**INSTRUCTION SUPPLEMENT
FOR
WJ-8716 HF RECEIVER**

PURPOSE OF ADDENDUM

REVISION
WJ-8718 SERIES HF RECEIVER

**WJ-8718 SERIES HF RECEIVER
CHANGE 1**

- 1.2 Revise Type 791578-1 Frequency Display (A8) schematic diagram, page 6-49, as shown.

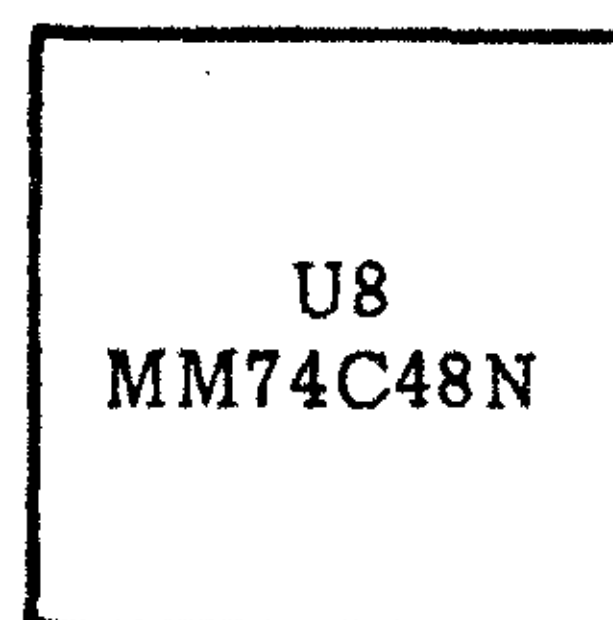
From:

To:

To: U8, Integrated Circuit, Qty 1, Part No. MM74C48N, Mfr.
Code 27014
